Wilgus, Sketch Plan No. 320190070

Completed: 7/15/2019

Description

Figure 10: Proposed Public and Private Streets

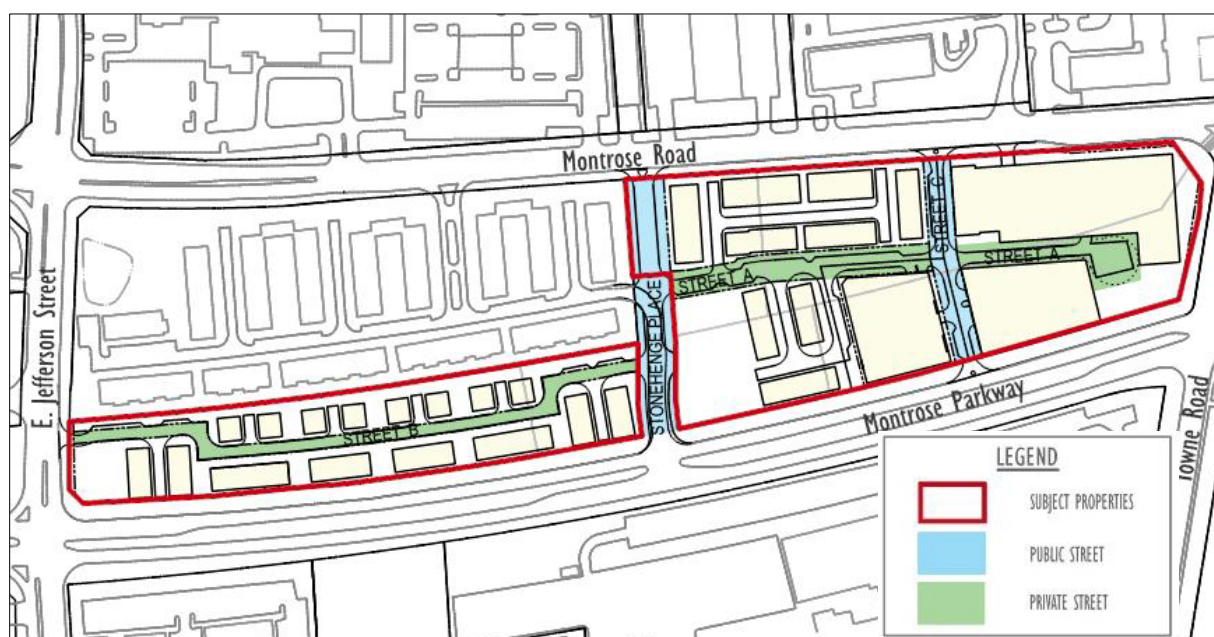
The Applicant proposes to dedicate the proposed portion of the north-south segment of Stonehenge Place and "Street C" as public streets, as shown in Figure 10. While staff supports this dedication, the Applicant may also be required to dedicate the portion of proposed private "Street A" between proposed public "Street C" and Stonehenge Place to public use as it is proposed to provide connectivity between two (2) public street segments. Public dedication would further justify the street's status as a "public benefit" per the Applicant's requested public benefit breakdown. Staff will continue to discuss this opportunity with the Applicant, and a determination will be made during review of the preliminary plan based on the Applicant's private street statement of justification.

Figure 15: Illustrative Towne Road Section

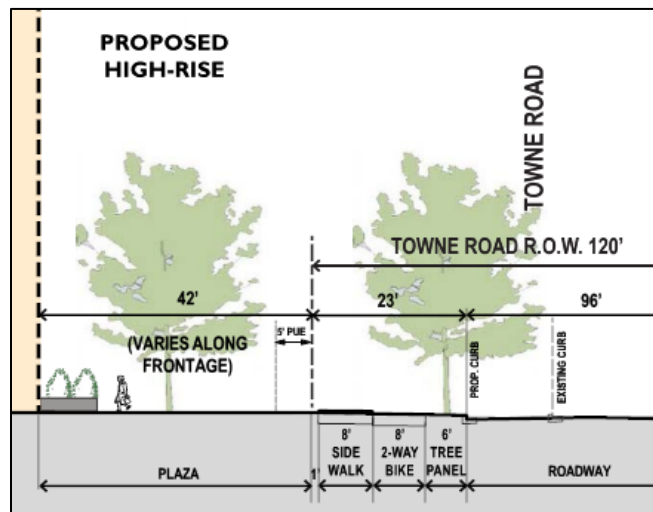
Staff will continue to work with the Applicant during review of the Preliminary Plan to ensure striping within the cartway meets the requirements of Chapter 49. Additionally, staff will work with MCDOT to confirm the necessary number of lanes adjacent to the site, which should be accounted for in the Applicant's transportation study.
